RESOURCE CONSENT HEARING

LAKES MARINA PROJECTS LTD (RM140061)

PLANNER'S S42A REPORT

SUBJECT Report on a notified land use and subdivision consent application to establish and operate a 195 berth marina, with associated wave attenuator (break water), commercial buildings, car parking, public open space, landscaping and earthworks.

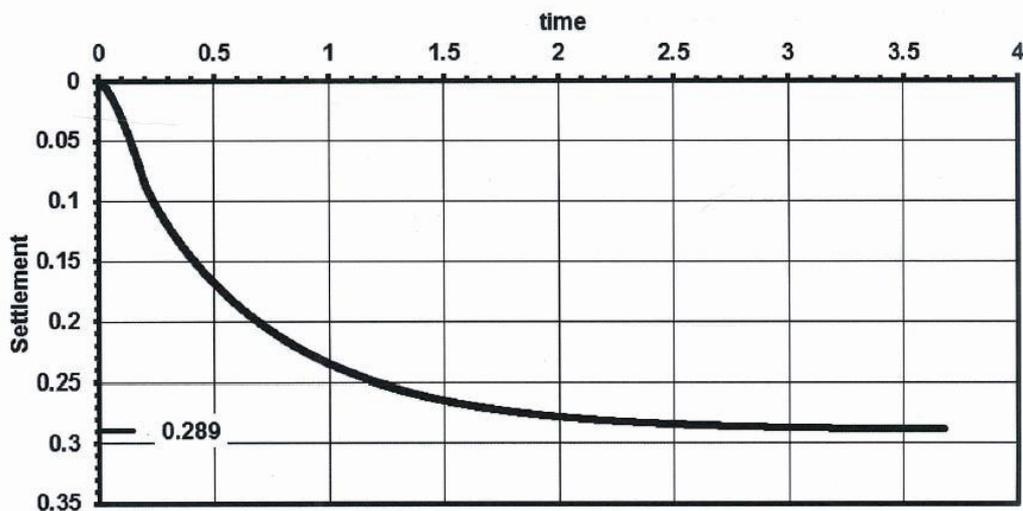
The first parking space on the right when entering the one-way section of the proposed car park may cause visibility issues for drivers reversing out of the adjacent spaces if it is occupied by a high sided vehicle. Perhaps this area could be used for motorcycle parking, covered if possible.

It is noted that the applicant proposes to install signage restricting use of this parking space to suitable vehicles. Mr Wardill does not consider limiting the use of this parking space as an issue and does not propose a condition in this regard.

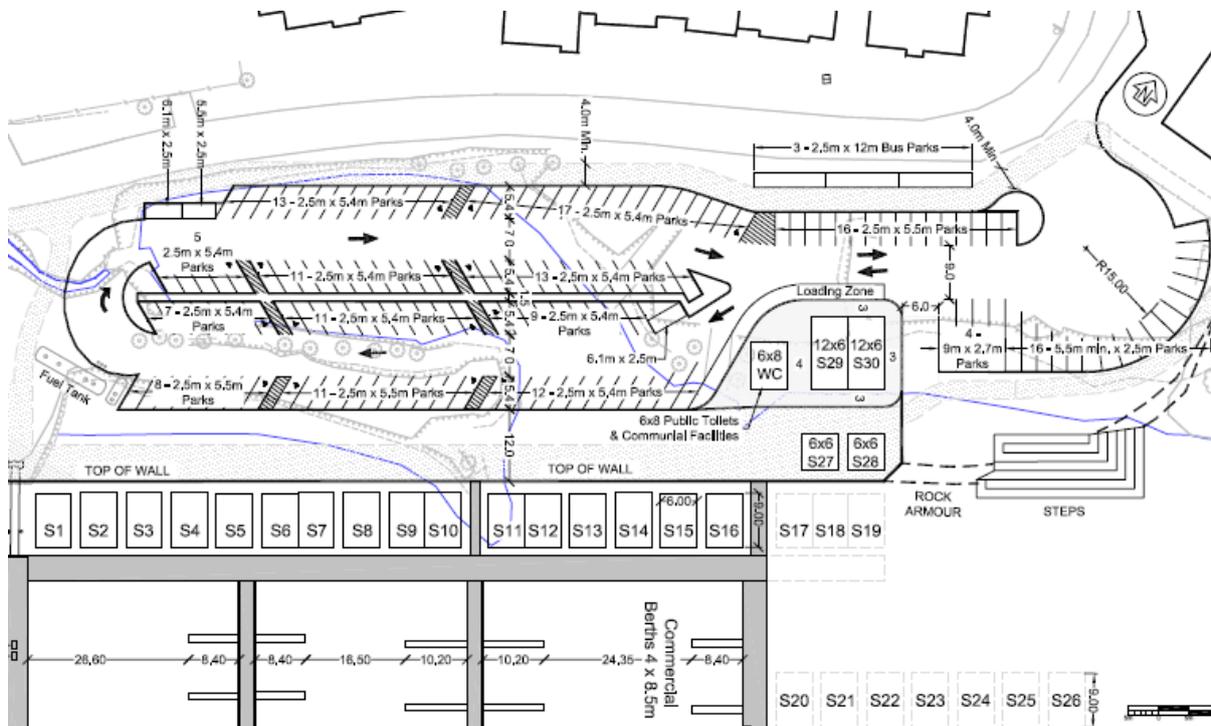
The District Plan Rule 14.2.4.1. (xii) requires parking surface to be formed, sealed or otherwise maintained to; prevent dust or noise nuisance, avoid water ponding, and to avoid runoff onto adjacent roads. Council's Engineer is of the opinion that with suitable management an unsealed surface can remain compliant until such time sealing occurs. A sealed surface will allow the appropriate parking markings to be applied thus avoiding illegal and unsafe parking, prevent gravels from being tracked onto the roading network and minimise potholing. The Emtech report proposes to defer kerbing and car parking until the marina is '*largely completed to achieve better compaction*' and avoid the effects of heavy construction equipment required throughout construction. Geosolve provide predicted settlement as follows;

Mr Wardill has assessed this issue and concluded that it is reasonable, in his opinion, for Council to allow a defined sealing delay for the main parking areas to allow time for settlement, and that combined with management controls any adverse effects should be avoided. Mr Wardill considers that a 24 month delay would cover construction settlement and include a buffer for the winter season.

He recommends the construction of 159 sealed vehicle manoeuvring and parking areas to Council standards including all necessary line marking. This shall be completed to all parking and manoeuvring areas within 24 months of completing the Stage 1 bulk earthworks. However, he does not consider that the delay shall apply to the marina entrance crossing point with the pedestrian

crossing. Mr Wardill has recommended that a bond be imposed to offset some risk to Council regarding the sealing delay.

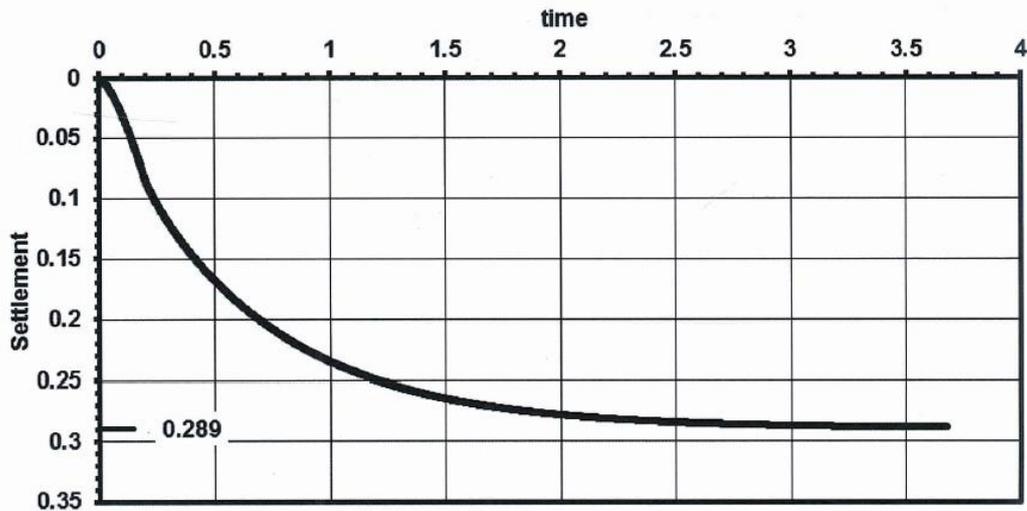
- *Anticipated vehicle speeds within the proposed development and on Sugar Lane should be considered and recorded by the applicant in support of 14.2.4.2 iv. (Page 20).*

- *The first parking space on the right when entering the one-way section of the proposed car park may cause visibility issues for drivers reversing out of the adjacent spaces if it is*

Sugar Lane is within a 50km/hr speed limit area however temporary signage has been installed by the Council restricting this to 20km/hr and this may become the permanent revised speed limit. Speed bumps along Sugar Lane provide positive speed controls. A 10km/hr speed restriction is proposed by the applicant within the development. A suitable condition of consent is recommended in this regard.
